# UNITED STATES PATENT AND TRADEMARK OFFICE

APPLICATION NO.	FILING DATE	FIRST NAMED INVENTOR	ATTORNEY DOCKET NO.	CONFIRMATION NO.
10/600,668	06/20/2003	John M. Lynch	P16911	5684
28062	7590 03/19/2004		EXAMINER	
BUCKLEY, MASCHOFF, TALWALKAR LLC			NGUYEN, TRUC T	
5 ELM STREET NEW CANAAN, CT 06840		ART UNIT	PAPER NUMBER	
			2833	
			DATE MAILED: 03/19/2004

Application No.	Applicant(s)				
	10/600,668	LYNCH ET AL.				
Office Action Summary	Examiner	Art Unit				
	Truc T. T. Nguyen	2833				
The MAILING DATE of this communication app Period for Reply	ears on the cover sheet with the c	orrespondence address				
A SHORTENED STATUTORY PERIOD FOR REPLY THE MAILING DATE OF THIS COMMUNICATION.  Extensions of time may be available under the provisions of 37 CFR 1.13 after SIX (6) MONTHS from the mailing date of this communication.  If the period for reply specified above is less than thirty (30) days, a reply If NO period for reply is specified above, the maximum statutory period vortice to reply within the set or extended period for reply will, by statute, Any reply received by the Office later than three months after the mailing earned patent term adjustment. See 37 CFR 1.704(b).	36(a). In n

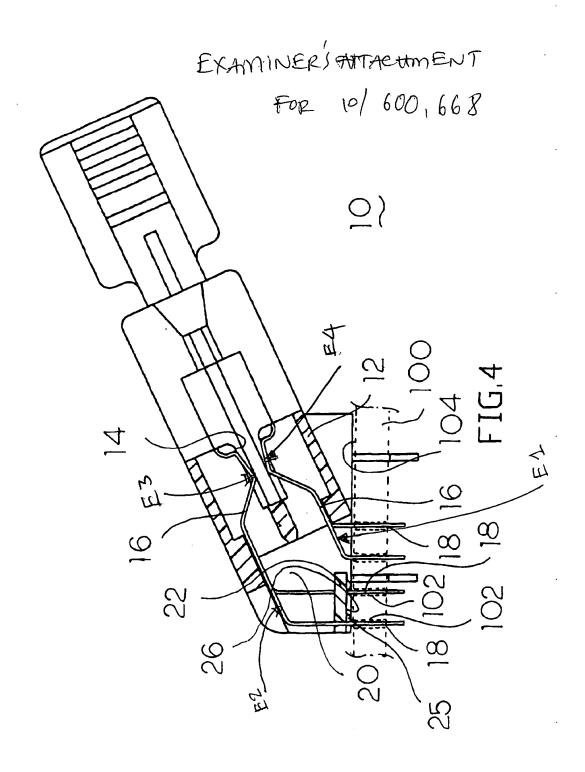
a first contact (E1, see Examiner's attachment) having a first length, a first module connection (E4, see Examiner's attachment) protrude into opening (14), a first signal line (18);

a second contact (E1) substantially the same with the first contact and dispose adjacent and on the same side with respect to the connector housing;

a third contact (E2, see Examiner's attachment) having a second length, a third module connection (E3, see Examiner's attachment) protrude into opening (14), a third signal line (18);

a fourth contact (E2) substantially the same with the third contact and dispose adjacent and on the same side with respect to the connector housing;
